Title	Comments on the Time Base Structure of TG3	
-------	---	--

Date Submitted	2001-01-17	
----------------	-------------------	--

Re:	IEEE 802.16.1/D1-2000, December 2000	
-----	--------------------------------------	--

FIGURE 1.

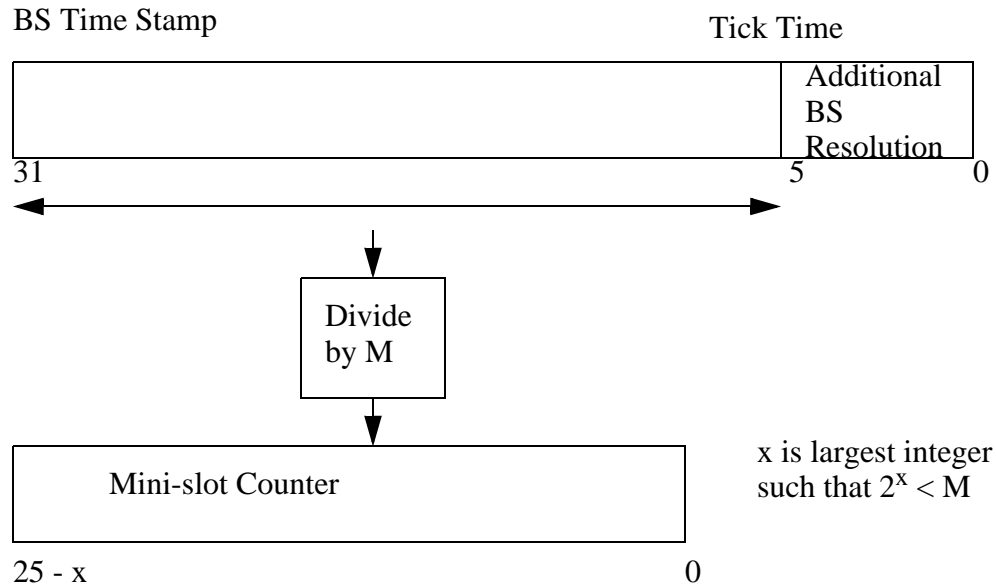
There are several issues that arise with this definition of the time base:

- As has been pointed out in [1], a single OFDM symbol can carry hundreds of bytes of data. Hence by specifying that the smallest time unit is 4 symbols, it forces the smallest transmission unit to contain a large amount of data, and also forces a very coarse level of granularity on all transmissions. This leads to waste of bandwidth and system in-efficiency.
- The size of the additional BS time resolution is a function of the symbol time. Once again, for OFDM systems this scheme does not work very well. For example, if the symbol time is 50 us, then the time resolution is 12.5 us, which is too coarse to do any meaningful distance ranging.

In order to resolve these issues, we propose the following alternative time base definition:

The base time unit is called a tick and is of duration 1 us, independent of the symbol rate, and is counted using a 26 bit counter. The additional BS resolution is of duration $(1 \text{ tick}/64) = 15.625 \text{ ns}$. The BS uses a 32 bit counter, of which the most significant 26 bits are used to count the ticks. The Mini-Slot count is derived from the tick count by means of a divide by M operation. Note that the divisor M is not necessarily a power of 2.

For arbitrary symbol rates, the main constraint in the definition of a mini-slot, is that the number of symbols per mini-slot be an integer. For example given a symbol rate of R Symbols/tick, and M ticks/mini-slot, the number of symbols per mini-slot N, is given by $N = MR$. In this situation, M should be chosen such that N is an integer. In order to accommodate a wide range of symbol rates, it is important not to constrain M to be a power of 2.

FIGURE 2. MAP relevance for burst PHY systems

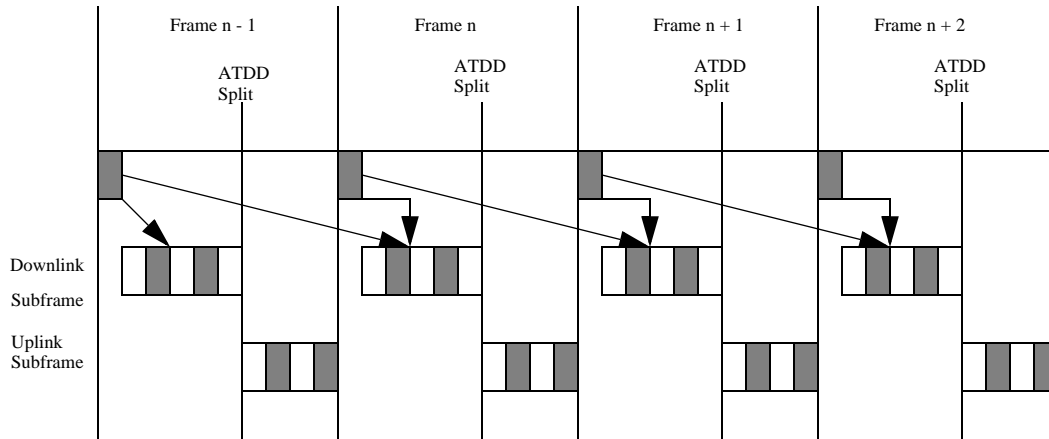
However for the TDD and HD-FDD case, there is no mechanism specified for sending the timestamp. Also the mini-slot count is reset at the start of every frame. The implication of this design is that it should be possible for the SS to achieve clock synchronization with the BS, without the use of periodic timestamps from the BS. This design should work in principle (albeit with a different PLL implementation at the CPE), however it leads to a loss of scheduling flexibility in certain cases, for example:

- The UL-MAP and DL-MAP packets are restricted to describing the frame in which they are sent: If the mini-slot count is not reset in every frame, then the MAP packets can describe parts of the next frame as well. Such a design can reduce the real time processing requirement at the CPE.
- The Acknowledgement Time field in the UL-MAP is restricted to refer to a time instant in the previous frame: This also imposes a real time constraint on the BS scheduler that it be invoked in the previous frame. If the scheduler is implemented in software, then this requirement may be difficult to meet. If the mini-slot count is not reset in every frame, then the ACK Time can describe a time instant that is further in the past, which will remove this constraint.

We propose that TDD and HD-FDD systems employ the same timestamp based synchronization scheme that is employed by FDD systems. These timestamps are broadcast by the BS to all the SS, in a special SYNC packet, rather than in the DL_MAP packet. We also

propose that the TDD and HD-FDD systems employ a running mini-slot count, rather than resetting it in every frame. These changes will lead to a common PLL design for FDD and TDD systems, and also increase the scheduling flexibility of the system.

As shown in Figure 4, the portion of the time axis described by a MAP is a contiguous area whose duration is equal to the size of a frame. In the example shown in Figure 4, it consists of a portion of the downstream time of the frame in which MAP is contained, the upstream time in this frame, followed by a portion of the downstream time in the next frame. The fraction of the downstream time in the current frame (or alternatively, the Allocation Start Time), is a quantity that is under the control of the scheduler, and when set to zero, corresponds to the Minimum Time Relevance scenario in Figure 56 of the TG1 specification. Note that with this design, it is no longer necessary to use a pre-defined set of frame sizes, but it can be changed under the control of the scheduler.

FIGURE 3. MAP Message Format

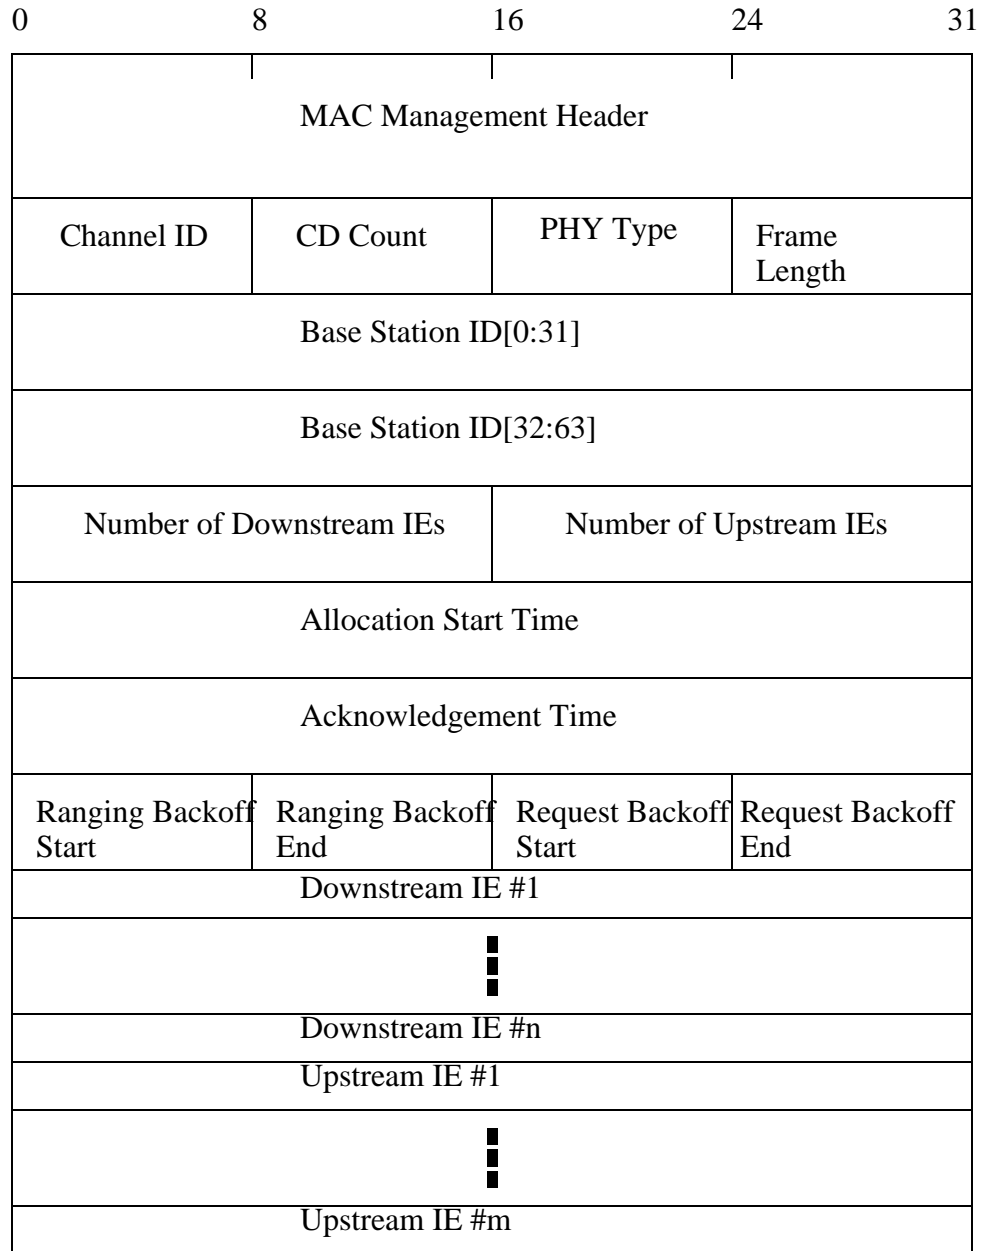
For TDD and HD-FDD systems, there is currently an asymmetry in the specification of the downstream and upstream bursts. Upstream bursts are defined in the UL-MAP message, while downstream bursts are defined in the DL-MAP message. This design has the following drawbacks:

- The location of upstream bursts is specified using mini-slot numbering, while the location of the downstream bursts is specified using physical slot (PS) numbering. This forces the MAP parser to use two different techniques for locating bursts. It would simplify things if the mini-slot based numbering was used to locate both upstream and downstream bursts.

- The identity of the Connection ID is specified only for upstream bursts, but not for downstream bursts. This forces the SS to receive and decode every downstream burst, which means that the BS is forced to transmit every downstream burst with maximum power so that it gets to every SS. This situation can be improved if the connection ID is also specified for downstream bursts. Thus the SS can then turn on its receiver only when it needs to receive a burst that is addressed to it. This will also allow the BS to vary the downstream power as a function of the SS to which the burst is going to, thus reducing the amount of interference.

If the above suggestions are accepted, then there is no need to have two different MAP messages, indeed the UL-MAP and DL-MAP messages can be consolidated into a single

Replace the contents of Section 6.2.1.2.3 by the following:

The MAP message allocates access to the upstream channel for FDD systems, and to both downstream and upstream slots for TDD and HD-FDD systems.

FIGURE 4. Downstream MAP IE Format for Downstream Data (DIUC = 8, 9, 10, 11, 12 or 13)

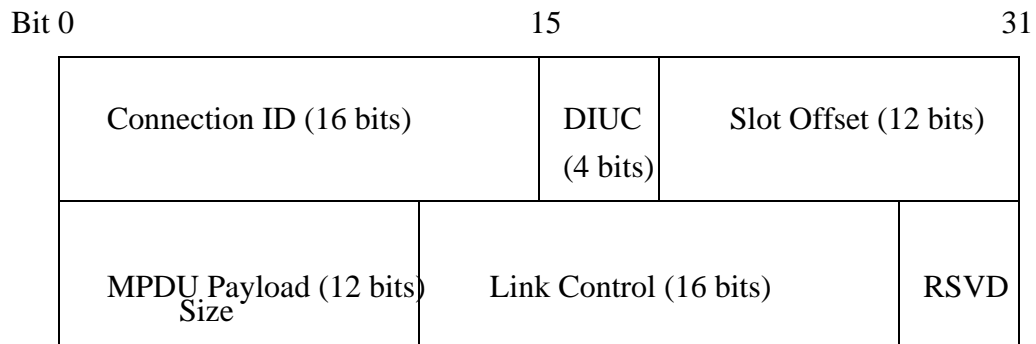
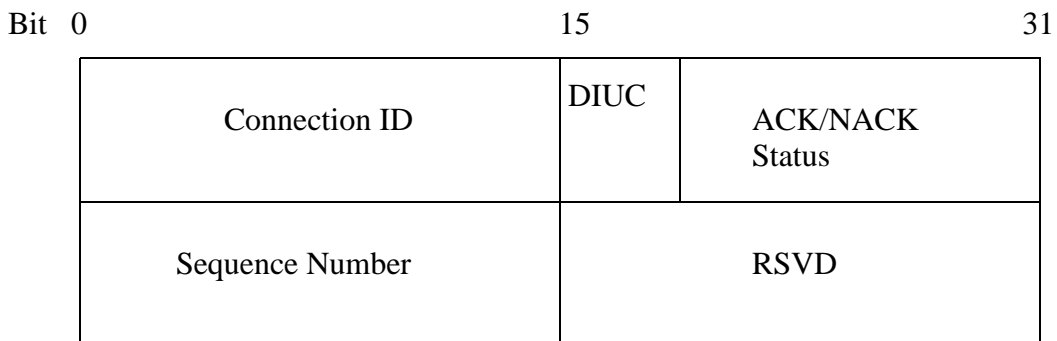
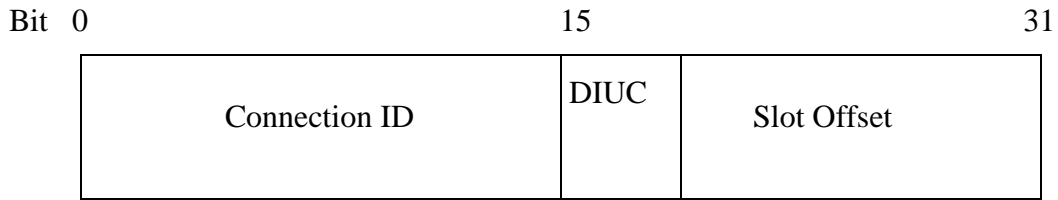
The TG1 specification defines downstream MAP IEs for the TDM case (Figure 15 of the TG1 specification), but not for the TDMA case. We complete the picture by defining MAP IEs for the TDMA case in Figure 13 of this contribution.

These are shown in Figures 13 and 14 and 15.
